### PRE-APPLICATION CONFERENCE NOTES Pioneer Cottages (PLZ-21-0123)

<b>Date</b>	Virtual conference held December 14, 2021 at 12:30 PM. Notes issued January 5, 2022
<b>Project Proposal</b>	Construct approximately 36 cottage housing units on 3.11 acres per RDC 18.206.040. Public infrastructure and improvements and community open space.
<b>Location</b>	No situs. #42 SEC 21 T4N R1EWM 3.11A Ridgefield, WA 98642; Assessor PIN 213991000
<b>Applicant &amp; Representative</b>	e-Terra, LLC, PO Box 2079, Battleground, WA. Contact: Beau Roberts, 360.787.6538, <a href="mailto:beau@eterrix.com">beau@eterrix.com</a>
<b>Property Owner</b>	Jeffrey & Francis Fandell, 610 E Raison Ct., Kuna ID , 83634
<b>Public Access</b>	Pioneer Street (SR 501) and N 50 <sup>th</sup> Place
<b>Zoning</b>	Residential Low Density - 8 (RLD-8)
<b>Review Required</b>	Pre-Application Conference for Cottage Housing, Critical Areas Permit, SEPA, modifications
<b>Potential Issues</b>	Binding site plan, subdivision, base zone standards, cottage housing standards, road improvements, vehicle trips, stormwater, utilities, and critical areas, archaeology.

**PIONEER VILLAGE**

**EXISTING CONDITIONS AND SITE PLAN**

**P2.0**

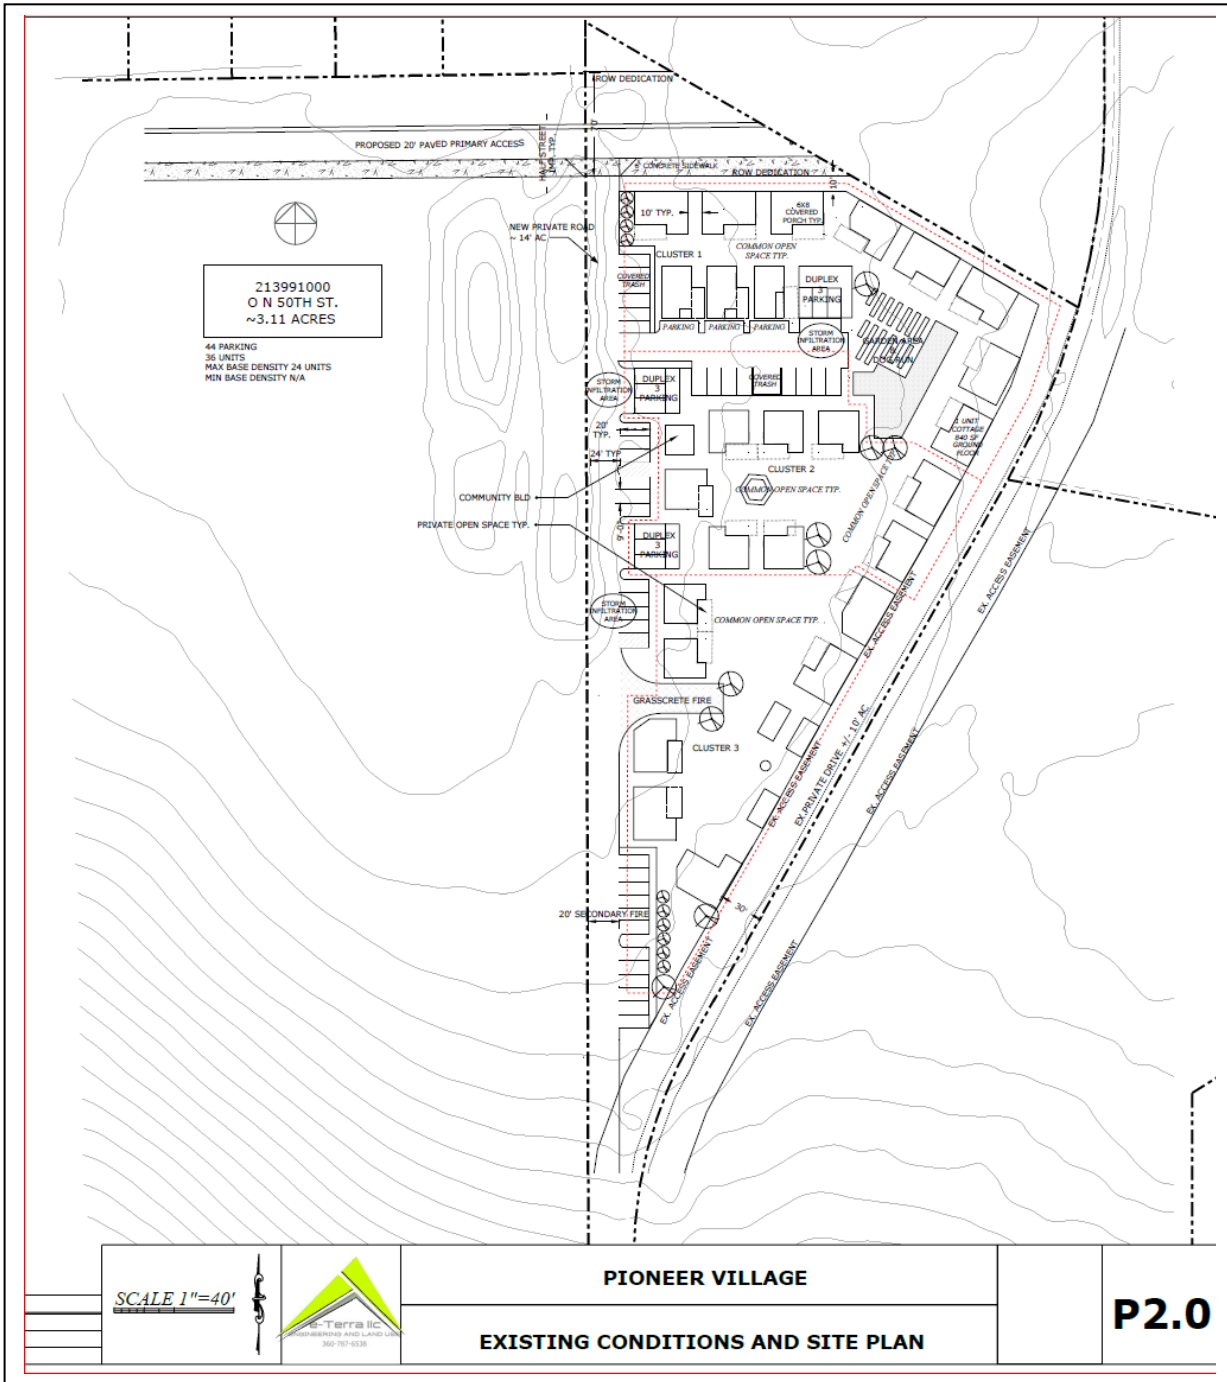
The Applicant proposed creation of 36 individual building lots and a network of private streets. However, city engineering standards expressly limit private streets to serving a maximum of eight lots. The city believes that subdivision of the site into 36 individual lots is not practical and is unlikely to be approved. Therefore, the city strongly recommends the Applicant to recraft the cottage housing proposal from a subdivision of 36 lots to a binding site plan of one or more lots, bearing in mind that the maximum number of lots or units that can be served by a private road is eight. The focus of these pre-application conference notes is, therefore, based on binding site plan review rather than subdivision review.

whether wetlands are present. The Applicant indicated an interest in discharging stormwater to the south towards an existing riparian area. If wetlands, riparian areas or attendant buffers are impacted, a Critical Area report is required.

**Street Improvements:** Right-of-way (ROW) dedication and full width construction will be required for N 5<sup>th</sup> St within the site's property boundary. Half width construction of N 51<sup>st</sup> Avenue will be required along the property's eastern boundary. Coordination with the City for the length of the required frontage improvements will be necessary to integrate the plans with the City's current project on N 50<sup>th</sup>/51<sup>st</sup> Avenue. At the project location, both N 51<sup>st</sup> Ave and N 5<sup>th</sup> St are industrial/commercial collectors and must be constructed to the City's industrial/commercial collector standard (Standard Detail T-2.4) with a 70-foot ROW and a 46 foot paved width. All associated improvements, including sidewalks, planter strips, street trees, and street lighting are required on all frontages.

Private streets may serve no more than eight lots and must not obstruct public street circulation. Private streets serving more than four lots must include curb, gutter, and sidewalk on one side of the roadway. Turnarounds shall be provided on all private streets longer than 150 feet.
